SUBJECT: POINT BEACH NUCLEAR PLANT, UNITS 1 AND 2 – STAFF ASSESSMENT
OF FLOODING FOCUSED EVALUATION (CAC NOS. MF9865 AND MF9866;
EPID L-2017-JLD-0013)

STAFF ASSESSMENT BY THE OFFICE OF NUCLEAR REACTOR REGULATION

POINT BEACH NUCLEAR PLANT, UNITS 1 AND 2

Figure 3.1.2 PBNP LIP Flood Maximum Water Surface Elevation.
Elevation is relative to NAVD88 (Source: Staff confirmatory analysis)

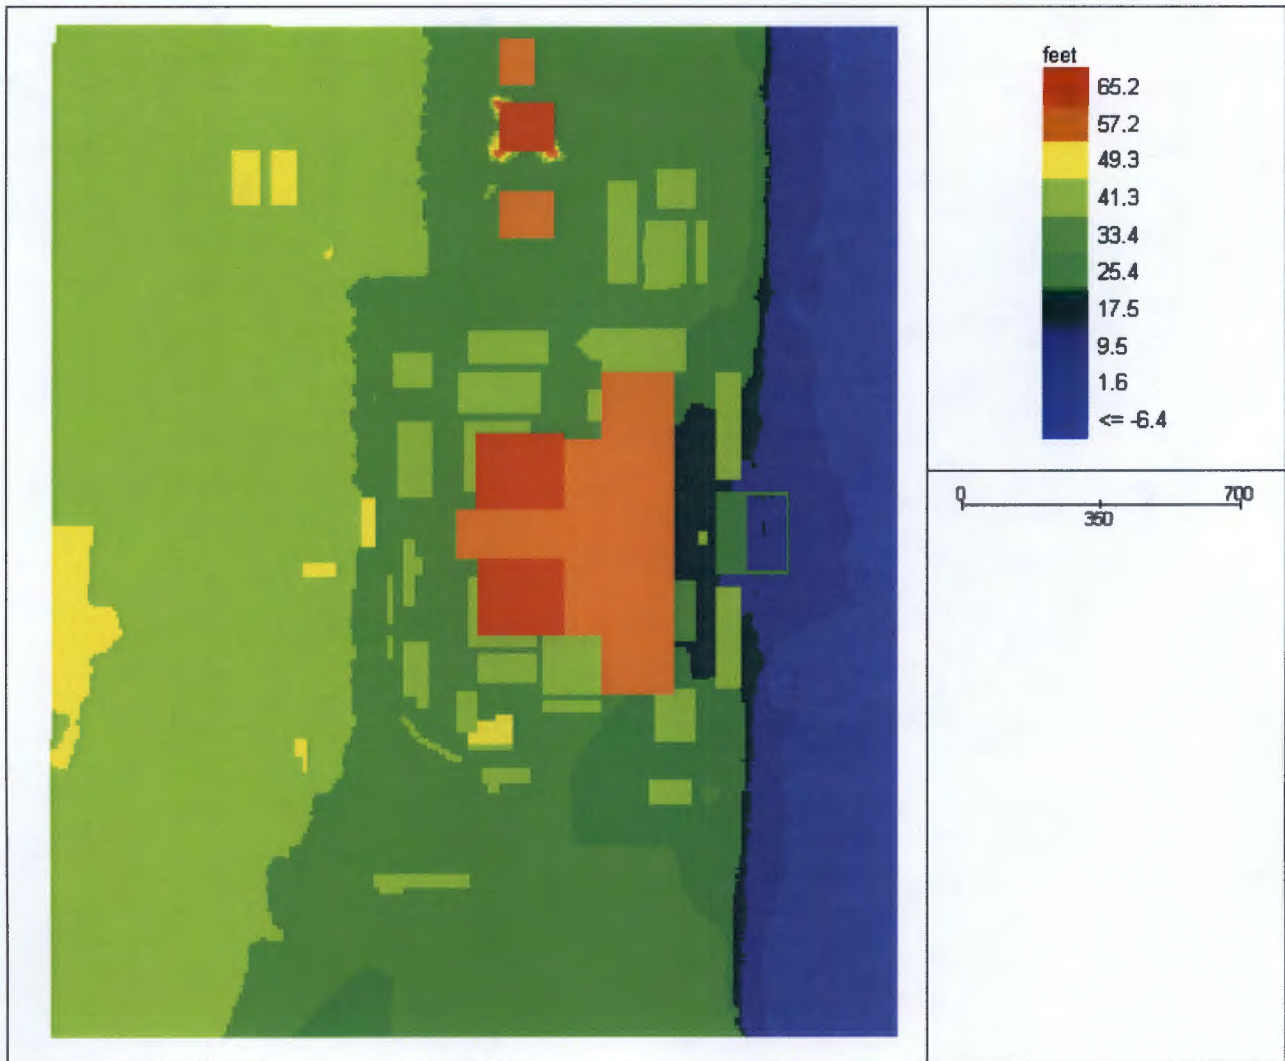
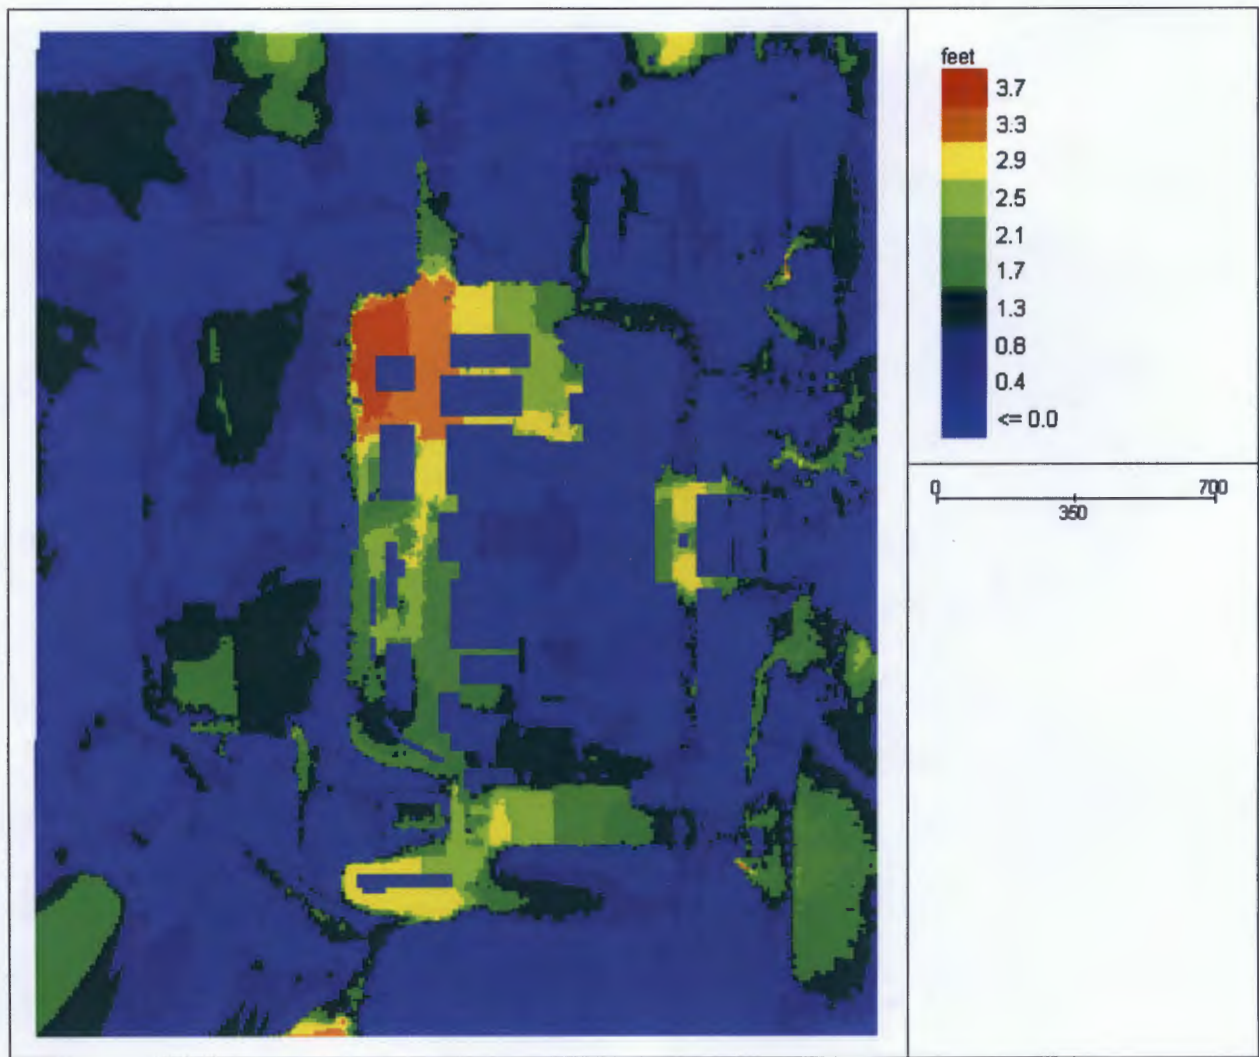
The licensee submitted four LIP temporal distributions and ten site configuration permutations to the NRC as part of the FHRR review. Model run ID SsSRTSQ4 closely matched the model configuration used by the licensee as part of the FE submittal. The NRC staff performed confirmatory modeling as part of its FE review, including modifying the drainage data in the FLO-2D model run ID SsSRTSQ4 in order to be consistent with changes described by the licensee in their FE submittal. The result of the NRC staff's confirmatory modeling analysis reasonably approximated the licensee's FE values. Specifically, the water depths matched the licensee's values to within 0.5 feet (ft.) at important-to-safety locations around the site.

Table 3.1-1 of this assessment summarizes the peak water depths at key monitoring locations for the LIP flood-causing mechanism. Table 3.1-2 compares peak water depths between the FHRR and the FE submittal. Table 3.2-3 presents the peak water elevations for flood-causing mechanisms that are not bounded by the current design basis. Figure 3.1.1 of this assessment presents the locations of points of interest relevant to the review, such as buildings and doors, provided by the licensee. Figures 3.1.2 and 3.1.3 were generated by the NRC staff during independent confirmatory analyses and present the maximum water surface elevations and maximum flow depths, respectively, resulting from the FE simulation. Figure 3.1.4 show sample hydrographs for Doors 4 and 13 and are generated from the NRC staff's confirmatory analysis and review of information provided with the MSA.

In summary, the NRC staff concludes that the revised maximum flood elevations reported in the FE are acceptable for use, and that the licensee used present-day methodologies and regulatory guidance.
